20-COA-0157
215 Saunders Ave.

Clifton Architectural Review Committee
Public Hearing

Bradley Fister, Historic Preservation Specialist
September 23, 2020 Continued from August 26, 2020

1ST FLR PLAN
3/16" = 1'-0"

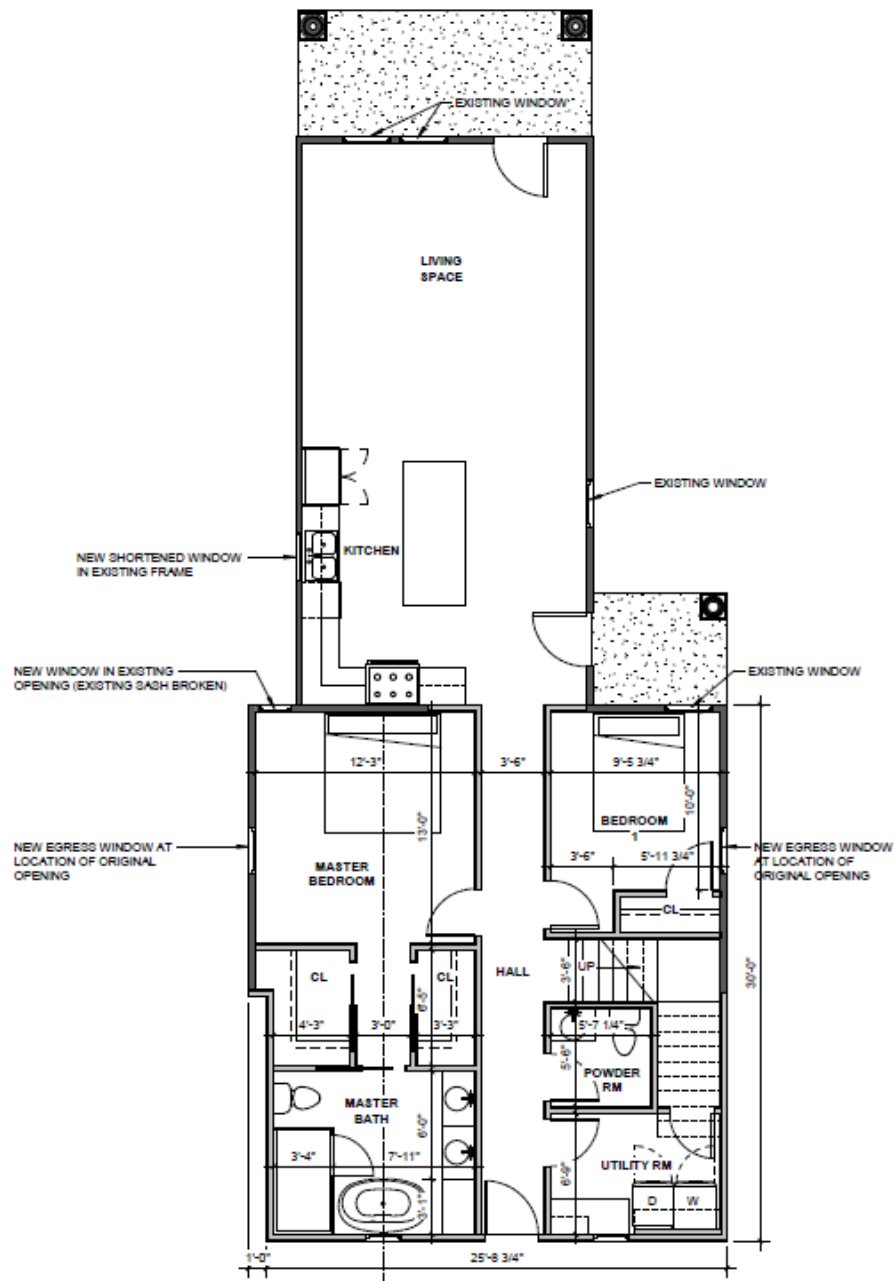
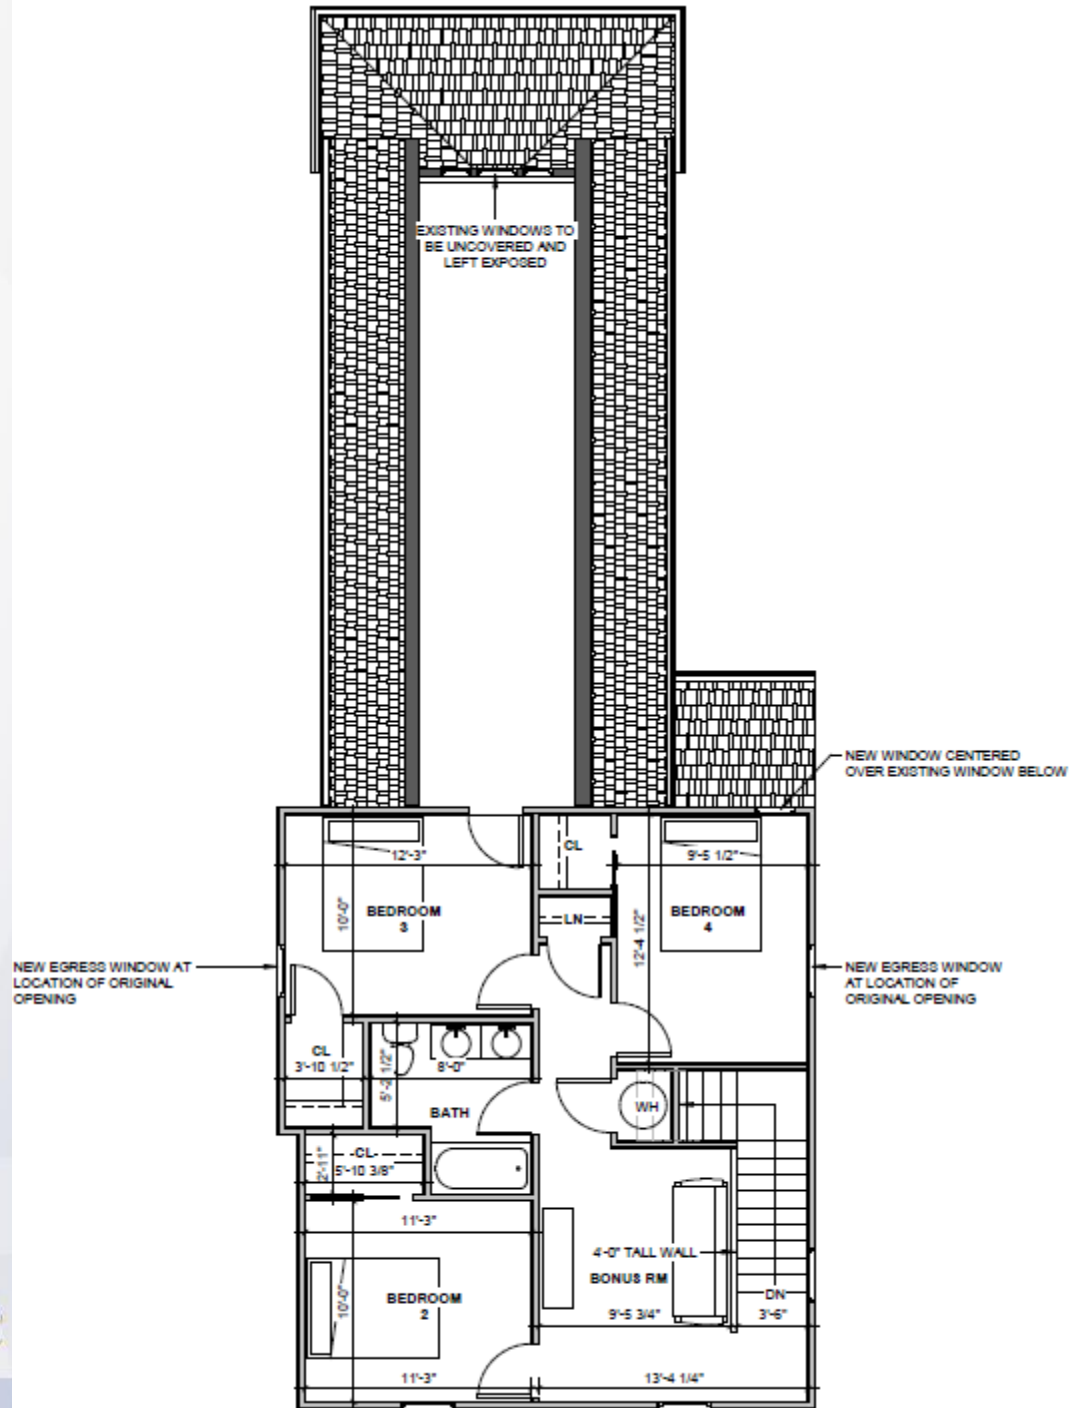
2. Two-story 'camelback' addition to the rear of the existing shotgun house. The addition is proposed to inset approximately 1' from the existing rear left corner of the house and extend outward in line with the

existing right rear corner of the house for a total width of approximately 24'-7 1/4" (original addition was not offset). The addition would extend from the back wall of the house toward the rear of the property approximately 12'-11" (roughly 2' further than the original addition to be demolished). The addition will include space on the first floor for a master bath, utility room,

powder room, staircase, and a door for egress to the back yard. The second story addition will include three bedrooms, a bonus-room, and a bathroom. The addition will be approximately 24'-10 9/16" in height with a 12/4 pitched gabled roof to be clad in shingles to match existing house. The existing square footage of the house is approximately 1431,

and the proposal would add another approximately 622 square feet for a total of approximately 2,053 square feet.
